From: Isa Yuen <[REDACTED]>
Sent: Thursday, January 15, 2026 8:55 PM
To: tpbpd/PLAND <tpbpd@pland.gov.hk>
Cc: Shirley Ka Kei CHAN/PLAND <[REDACTED]>; Samuel Xing WANG/MND/DSD <[REDACTED]>; Shinuo DENG/LDD/DSD <[REDACTED]>; Thomas Luk <[REDACTED]>
Subject: [PLG10315] Planning Application No. A/NE-FTA/264 - Further Information (4)

**Re: Section 16 Planning Application for Proposed Temporary Warehouse (excluding Dangerous Goods Godown) and Open Storage of Construction Material and Machineries with Ancillary Facilities for a Period of 3 Years and Associated Filling of Land at Lot Nos 346, 347 S.A, 347 S.B, 347 RP, 348 RP, 349 RP, 351 RP, 352 S.B RP, 361 RP (Part), 366 RP in D.D. 87 and Adjoining Government Land, Kong Nga Po, Sheung Shui, New Territories
(Planning Application No. A/NE-FTA/264)**

Submission of Drainage Impact Assessment

Figure 1: Modification to Branch 9 and storage tank A

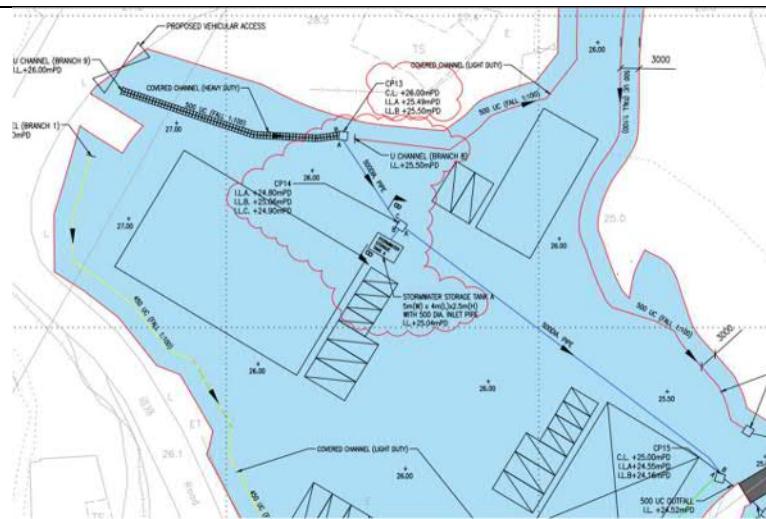
| | Comment from DSD | Responses |
|---|---|--|
| 2 | <p>Calculation of the storage tank was not found. Please describe the storage tank's design intent, operational mechanism and hydraulic performance.</p> | <p>The storage tank is modelled in the Infowork. Please refer to Drawing No. WNG/25086/C/DRA/004 for details and dimension of the tank.</p> <p>The layout of branch 9 and branch 5 is modified so when extreme rainfall occurs, the excessive stormwater will flow into the tank instead of the stream. Temporarily storing incoming peak flows, thereby attenuating the discharge.</p> |

Operational Mechanism and Hydraulic Performance: In extreme rainfall events, the inlet pipe connected to the downstream end of existing surface channel diverts into the tank. The stored water in the tank will be emptied by pump after the rainfall

Storage tank A: The inlet level of the tank is set at the highest water level (for branch 9) during the peak flow (see the figure below). This ensures that only

excessive stormwater is diverted into the tank for temporary detention. Once rainfall subsides, the stored water will be pumped out to restore the tank's capacity for the next event.

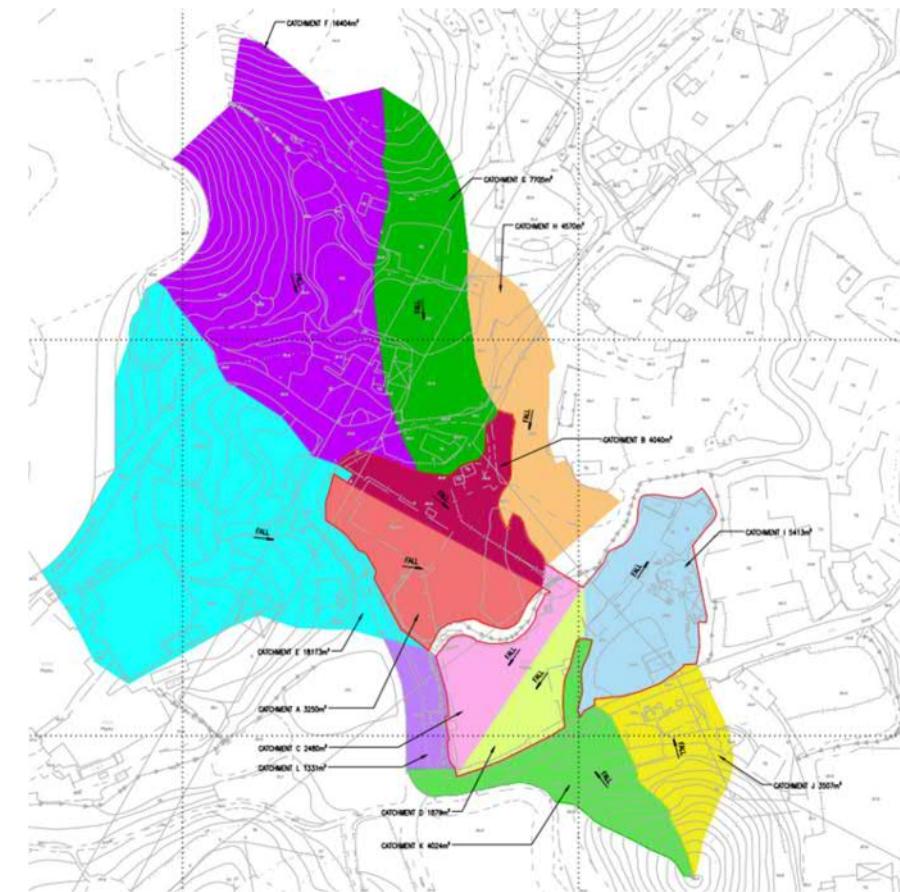
| 7 | The depth of landfilling works could be up to 3m as inferred from Figure 3-3, which contradicts with response in RtoC item 13. Please clarify. | <p>To clarify, there will be filling to create a flat surface with slight gradient to provide falls to drainage features and match the existing road surface outside the lot boundary.</p> <p>The design of the site's grading and drainage system specifically ensures that the finished filling levels and gradients will direct overland flow into the proposed internal drainage network. This system has sufficient capacity to collect and convey all surface runoff (refer to calculation in Appendix C), including flows from adjacent catchments to the approved downstream discharge point without causing obstruction or flooding.</p> |

| Catchment (outside lot) | Existing ground level (mPD) | Adjacent catchment (color) | Ground level (mPD) |
| E (Cyan) | +27.0 | A (Orange) | +26-27.0 |
| F (Purple) | +27.5 | B (Red) | +25.0-26.0 |
| G (Green) | +26.1-27.4 | B (Red) | +25.0-26.0 |
| H (Skin) | +25.0-25.5 | B (Red) | +25.0-26.0 |

| Furthermore, as shown in the table, although the lot is filled to a higher platform level, the finished level will remain lower than the adjacent catchment. Thus, the filling works will not obstruct the overland flow path. | | | | | |
